MILITARY SPECIFICATION

FILTER UNIT, FLUID, PRESSURE MXU-408/M,
ABSOLUTE 5 MICRON, HYDRAULIC

This amendment forms a part of Military Specification MIL-F-27656B dated 29 November 1968, and is approved for use by all Departments and Agencies of the Department of Defense.

FIGURE 2. Element Envelope Dimensions

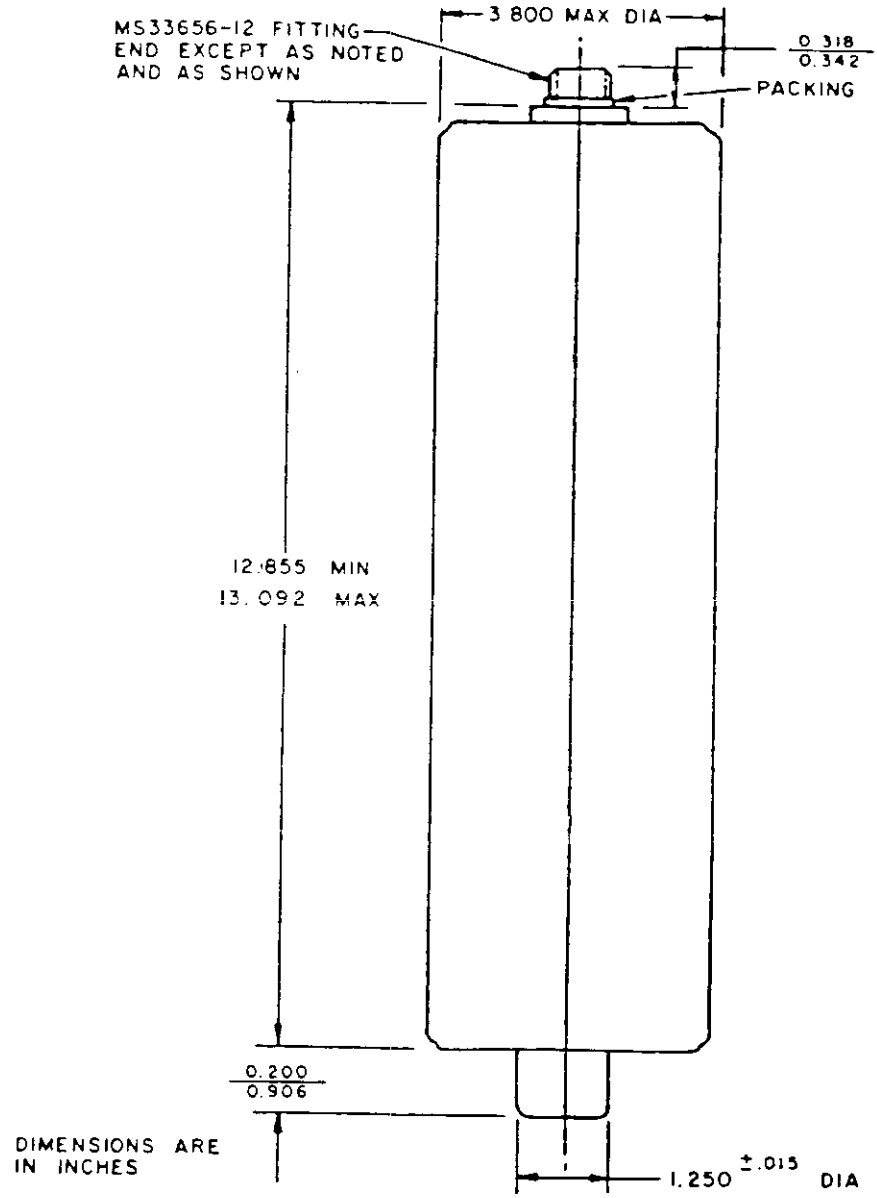
Delete Figure 2 and substitute the attached Figure 2:

Figure 2 forms page 4 of this amendment.
